## PLANNING COMMISSION MEETING

**RE: Ginko Self Storage -Final Site Plan/Final Engineering Plan Review-3<sup>rd</sup> Review  
Stormwater Maintenance Agreement Review-1<sup>st</sup> Review**

## Revised Final Site Plan Review for Special Land Use for White Lake Charter Township, Michigan

# GINKO SELF STORAGE

LB 16 - LB 3 PROFILE

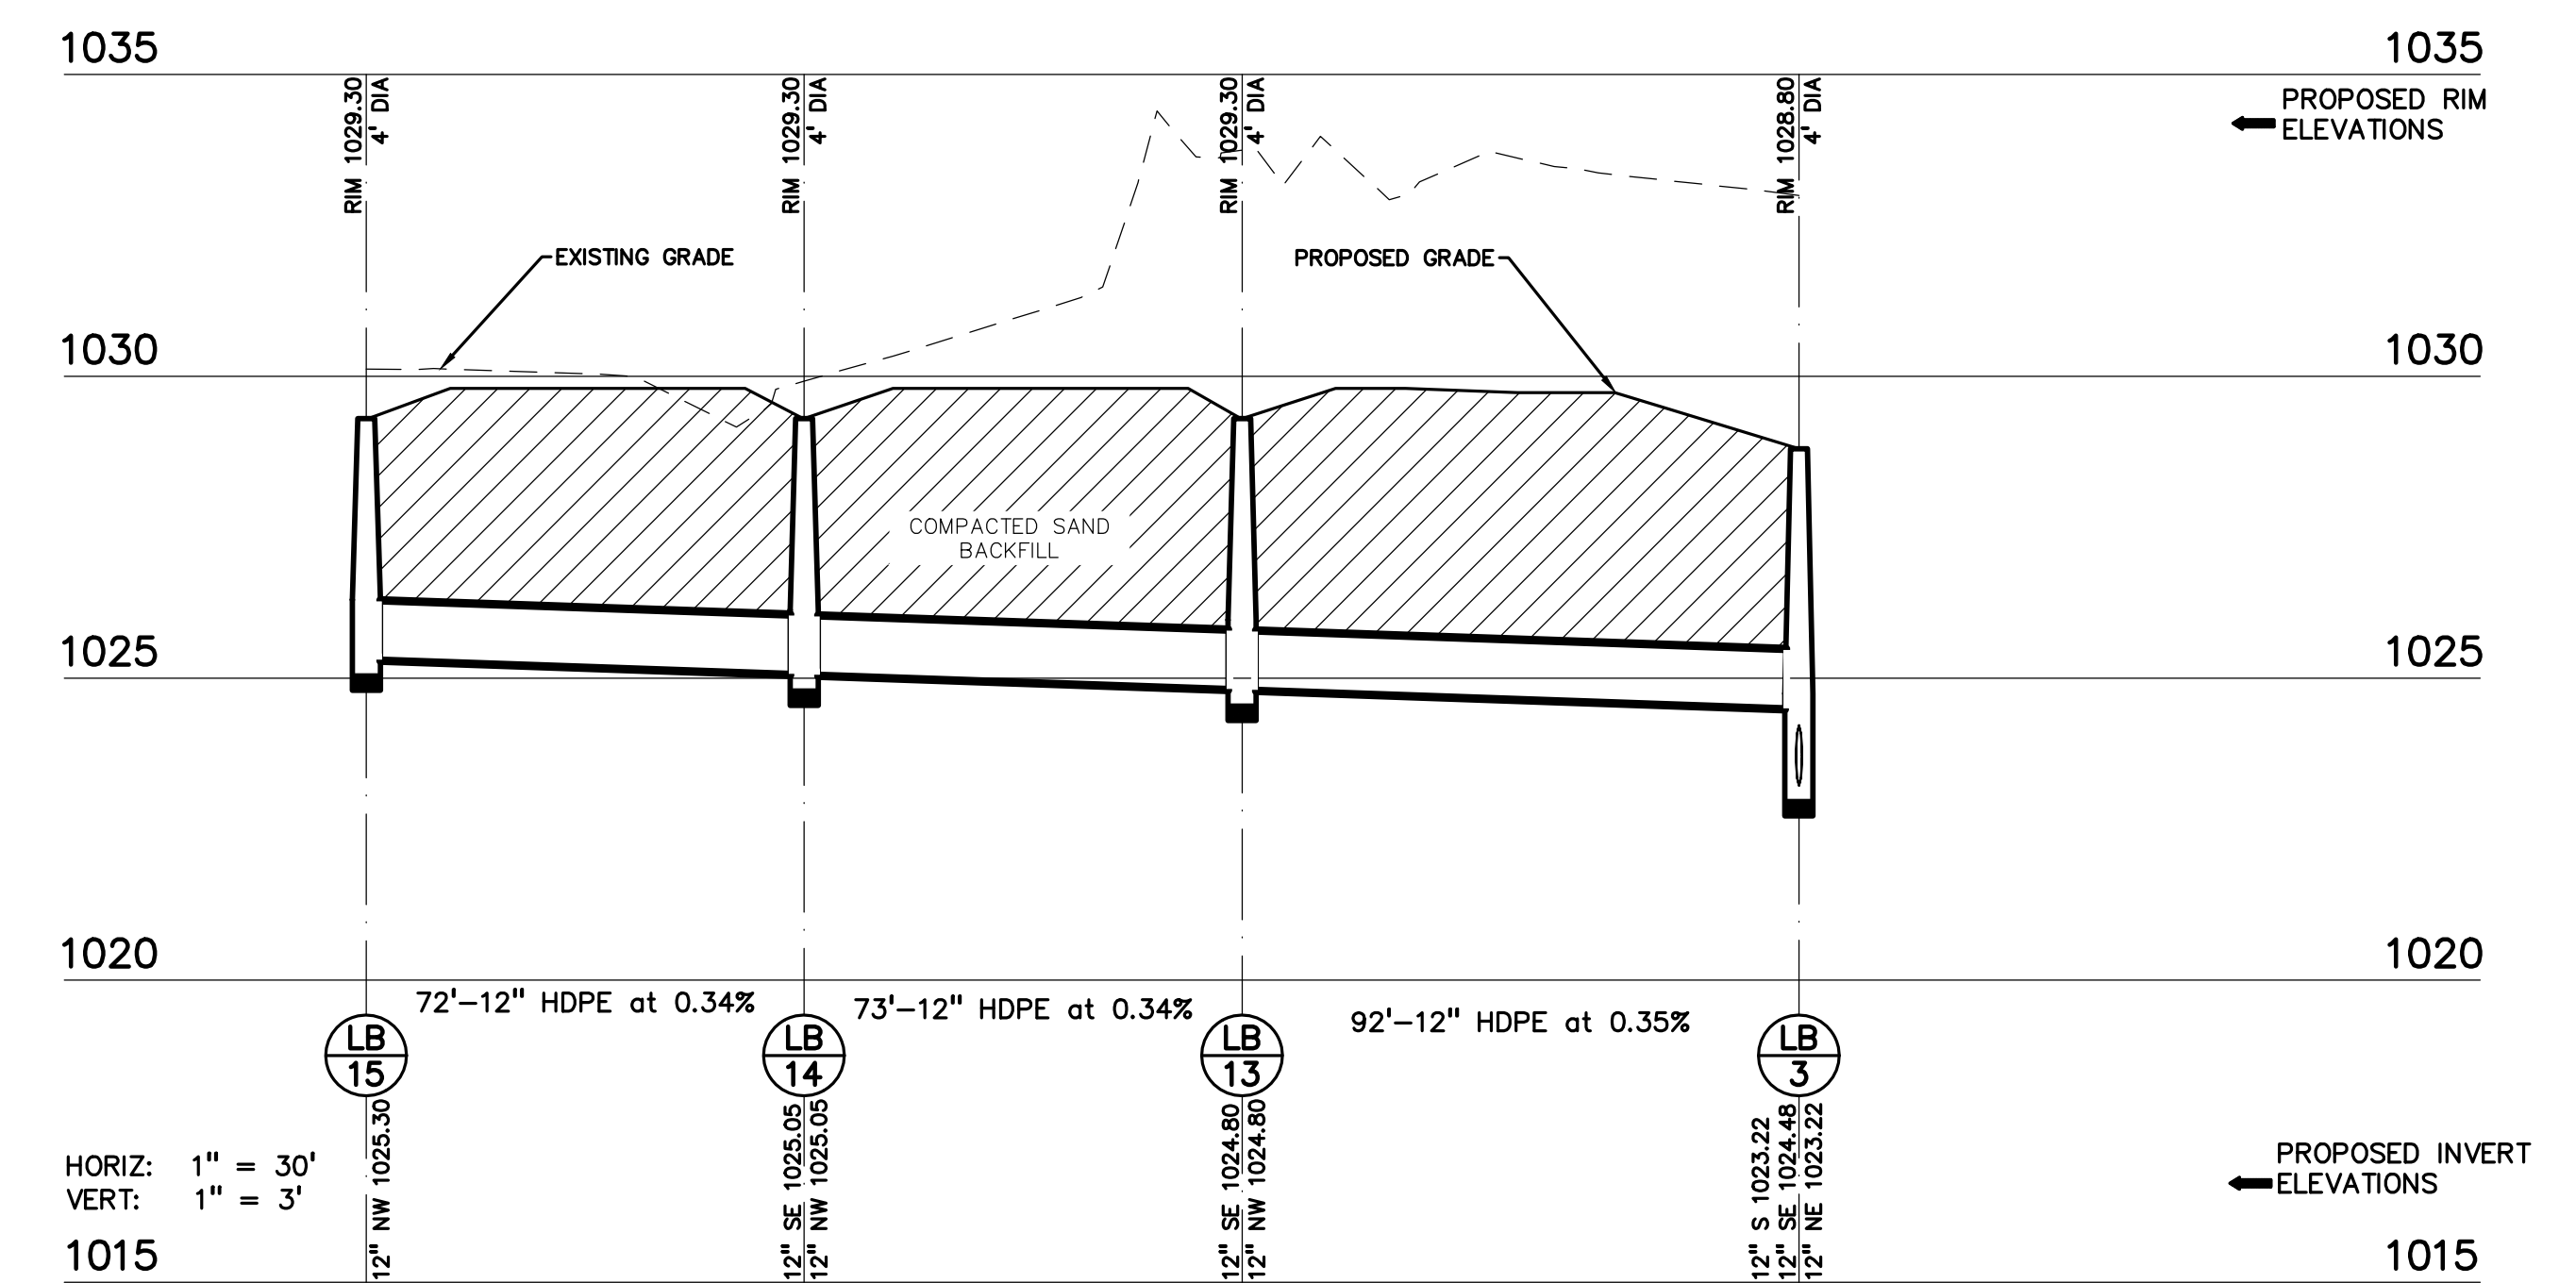
2. *Sheet C-7.0- The following pipe segments do not match Sheet C-6.0 in terms of footage, slope, or both. Please revise: 1) ES1-LB2; 2) LB4-MH5; 3) MH5-LB6; 4) LB6-LB7; 5) LB8-LB9; 6) LB2-LB10; 7) LB10-LB11; 8) LB11-LB12; 9) MH5-LB17; 10) LB13-LB14; 11) LB14-LB15. Comment partially addressed. Footages and slopes have been adjusted and now match with the exception of LB2-ES1. **Comment partially addressed. LB2-ES1 footage and slope now match; however, it now appears that the footage for LB3-LB-2 was adjusted and now does not match between Sheets C-6.0 and C-7.0.***

DRAWING NUMBER:  
**L-1.0**

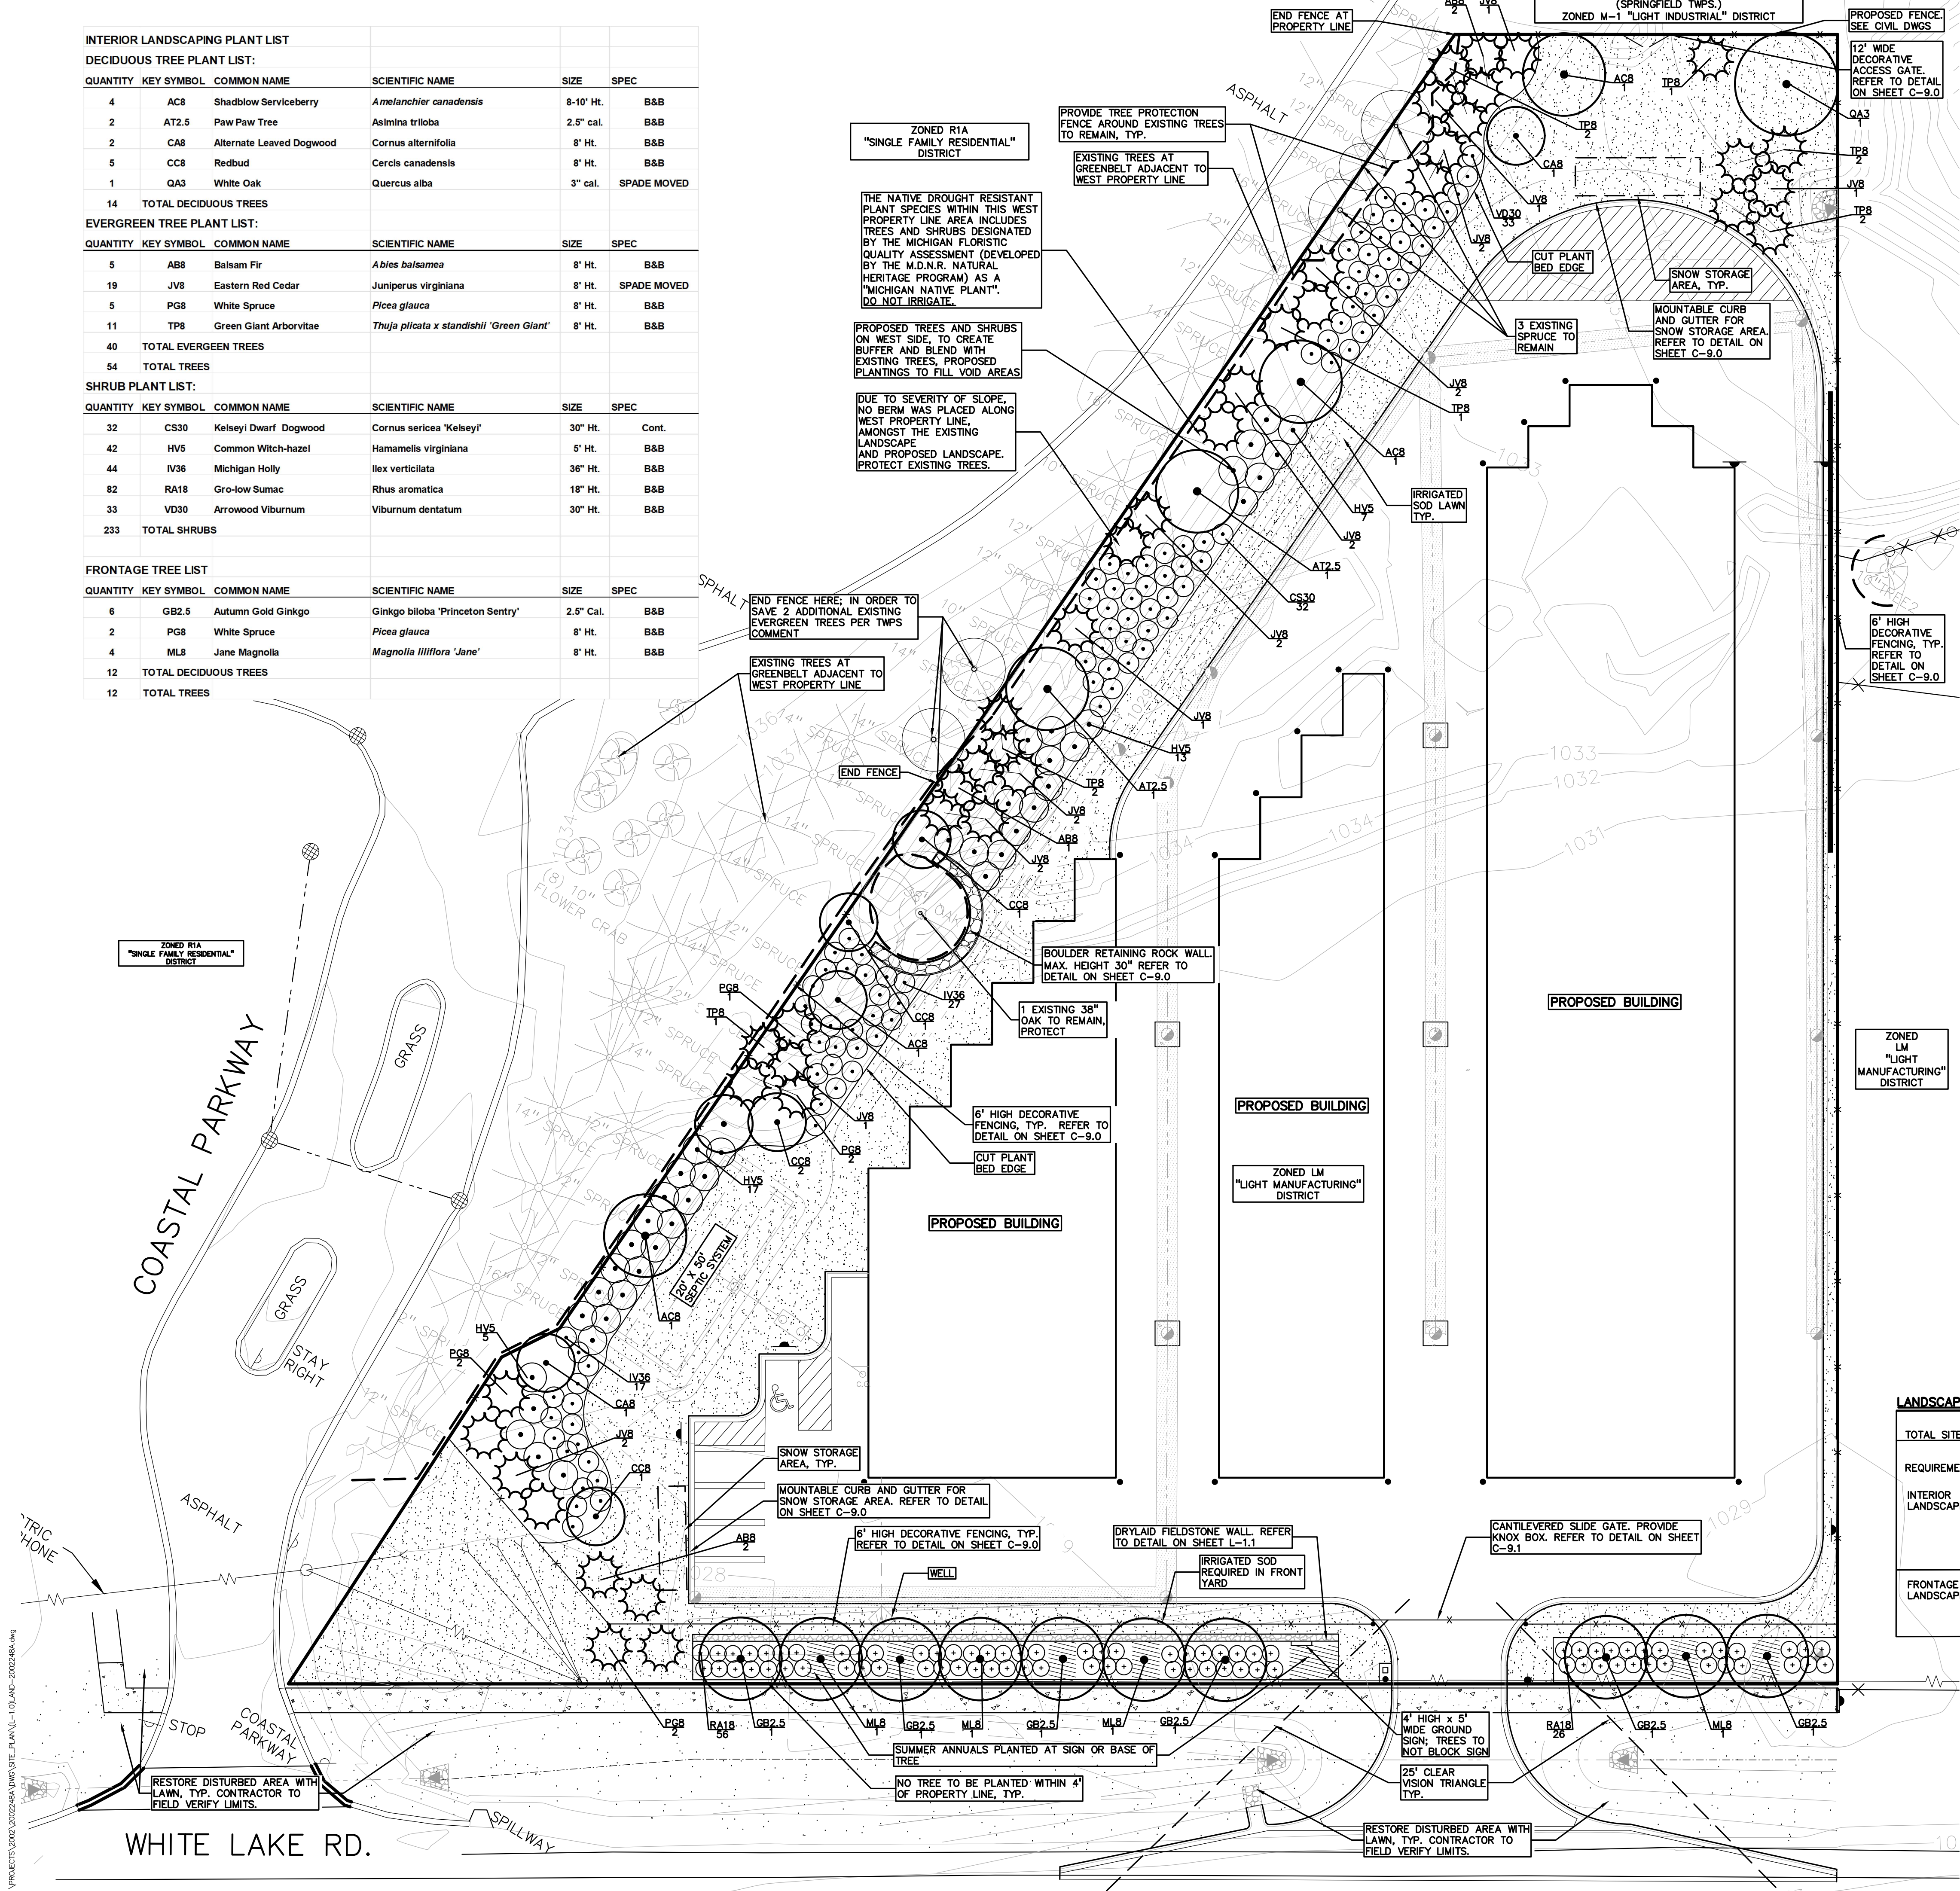
Sheet L-1.0 shows a dense array of new and existing deciduous and evergreen trees as well as numerous shrubs along the western property line. Protective fencing is shown encompassing existing trees during construction. A twenty (20) foot wide buffer is shown along White Lake Road and meets the requirements of landscape screening variance along the right of way.

Sheet L-1.0 indicates the two evergreen trees to be saved by the modified fence design.

Information provided on Sheet L-1.0 indicates irrigated portions of the site as well as a note stating irrigation plans to be provided at final site plan with rain sensors. These notes and irrigated areas are carried over from drawings dated October 24, 2023. Acceptable irrigation plans and designs should be submitted for consideration by the Planning Commission.

Sheet L-1.0 provides planting materials and sizes as well as indicates the construction of a rock retaining wall used to protect an existing mature oak tree. Based on landscaping standards for the LM district and the variances granted by the Zoning Board of Appeals, the site meets or exceeds the required plantings.

**Items to be Addressed:** 1.) *ZBA meeting in which variances were granted should be corrected to March 28, 2024 as shown on Sheet C-3.0. Addressed.* 2.) *Tree spacing dimensions along White Lake Road should be added to Sheet L-1.0 to confirm the ZBA condition from the March 28, 2024 meeting. Addressed* 3.) *Sheet L-1.0 should be updated to align with fence placement shown on Sheet C-3.0 and contain a note indicating the evergreen trees to be saved by this modification. Addressed* 4.) *A note should be added Sheet L-1.0 indicating why the decorative fence is not proposed to encompass the site with exception of the portion being shortened to preserve two existing evergreen trees. Addressed* 5.) *Acceptable irrigation plans and designs should be submitted for consideration by the Planning Commission and/or Building Official. Addressed.* 6.) *The Planning Commission will need to determine if the non-obscuring fencing is acceptable. Comment remains as a notation.*
